# Customer Notification of Product/Process Changes

\*PCN No.: PCN-0076

\*Subject: Change SMB 6Row to 16Row design

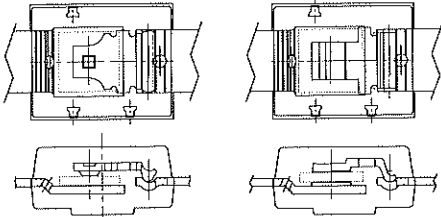
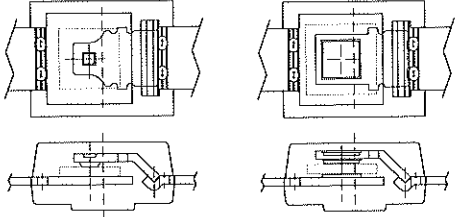
1. SMB 6Row with support bar and distinct clamping line. 2. SMB 6Row lead frame with down set & pad size is 2.2*2.2mm. 3. Package capability of die size range: 32mil~80mil	1. SMB 16Row without support bar. 2. SMB 16Row lead frame without down set & pad size is 2.67*2.90mm. 3. Package capability of die size range: 32mil~100mil
